McKeever's Market #950 – Lee's Summit, MO

RE: RFI #10 – Light Pole Base Detail

Drawing: E1.2 –Site Electrical Plan

2 POLE BASE DETAIL

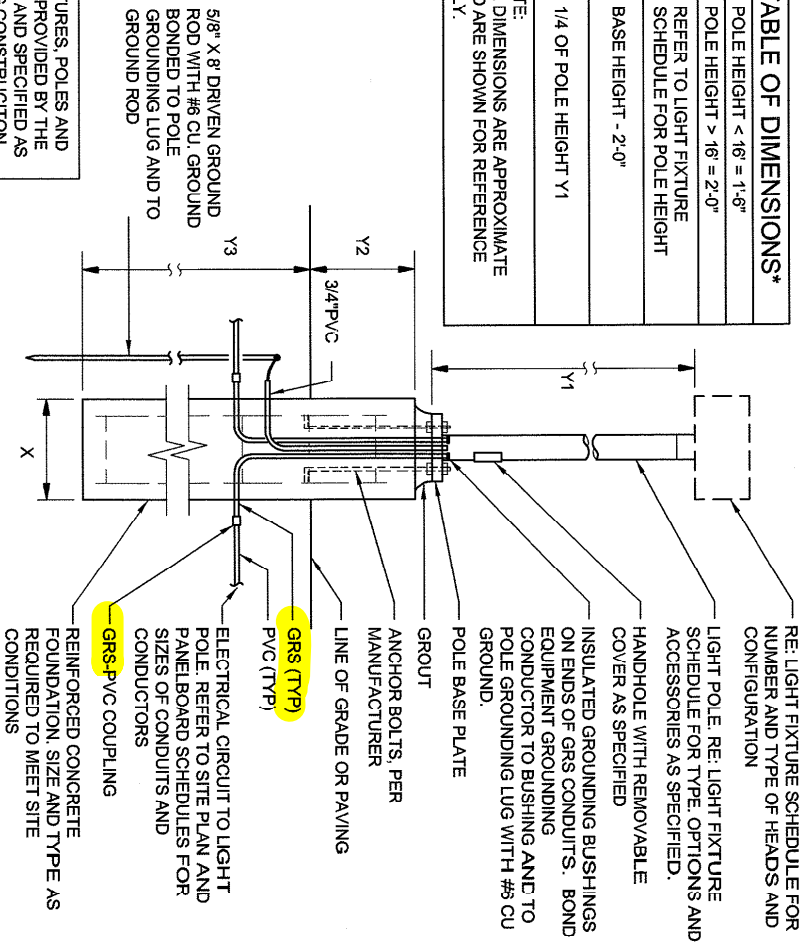
Is it acceptable to use PVC conduit embedded in the concrete light pole base instead of GRS?

PVC is acceptable to Henderson.
